FORD AXOD/AXOD-E

NEW DESIGN INPUT PLANETARY CARRIER SUN GEAR AND SHELL ASSEMBLY

FIGURE 1

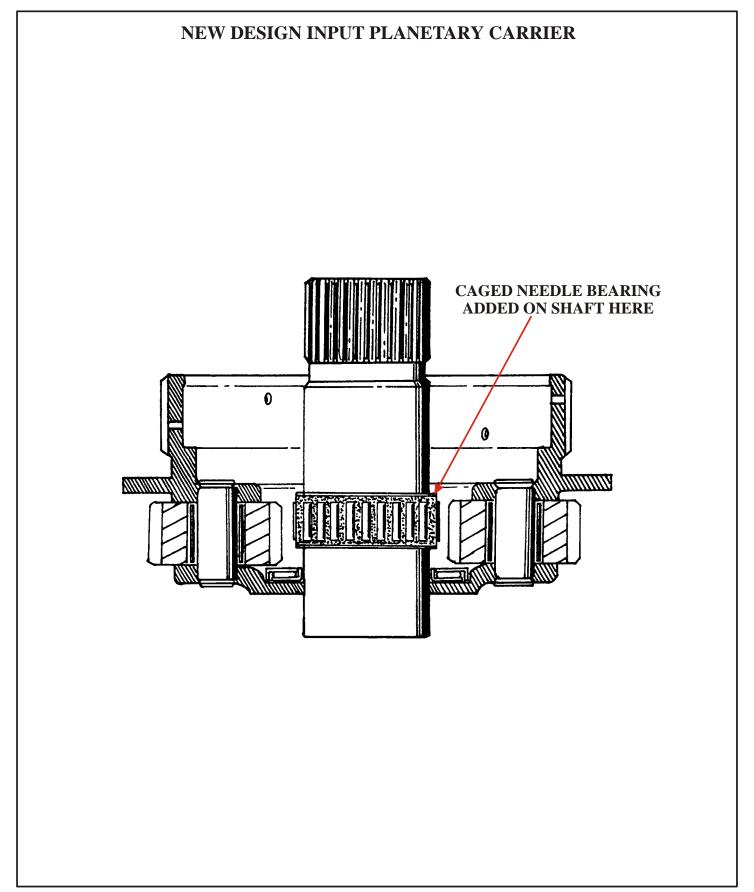
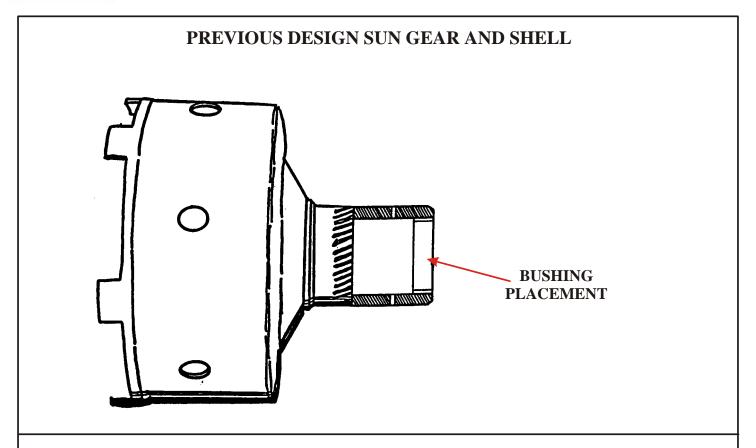
(1) INPUT PLANETARY CARRIER - A new caged needle bearing has been added to the shaft on the Input Planetary Carrier, as shown in Figure 1.

FIGURE 2

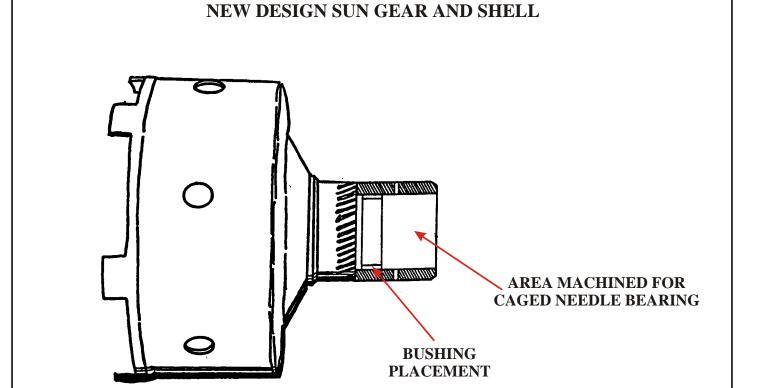
(2) SUN GEAR AND SHELL ASSEMBLY - Single bushing is now located in front of the lube holes in the sun gear, and the area behind it is now machined to accommodate the new caged needle bearing, as shown in Figure 2.
